SERVICE BULLETIN

ENGINE - DIFFUSER AND COMBUSTION GROUP - REPLACE THE NO.4 BEARING PRESSURE TUBE ASSEMBLY GASKET - CATEGORY CODE 6 - MOD.ENG-72-0071

V2500-ENG-72-0071

Location of No.4 bearing pressure tube assembly gasket
Fig.1

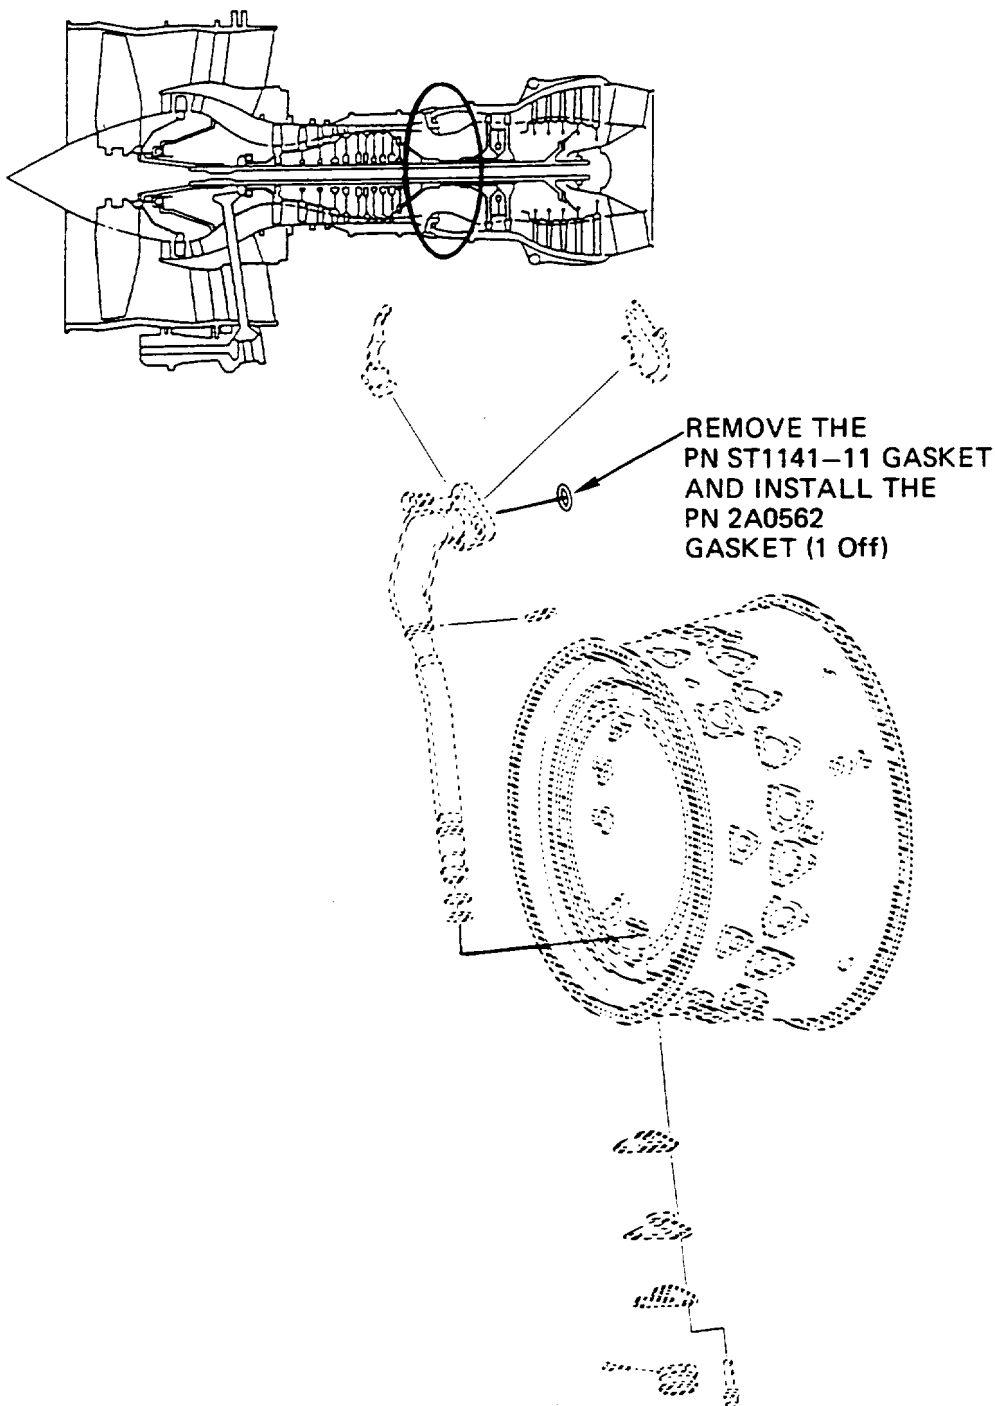
The gasket on the No.4 Bearing Pressure Tube Assembly did not have a 360 degree sealing surface contact area with the No.4 Bearing Support Assembly in the assembled position.

High oil consumption was found on Engine Serial No.V0049. Oil was leaking by the gasket between the No.4 Bearing Pressure Tube Assembly and the No.4 Bearing Support Assembly.

- (1) To prevent the oil leakage at the No.4 Bearing Pressure Tube Assembly Gasket; A new gasket is provided with a 360 degree sealing surface.

- (1) Install the 2A0562 No.4 Bearing Pressure Tube Assembly Gasket (1 off) by the approved procedure in Reference (1), Chapter/Section 72-42-00, Assembly, Figure 1.
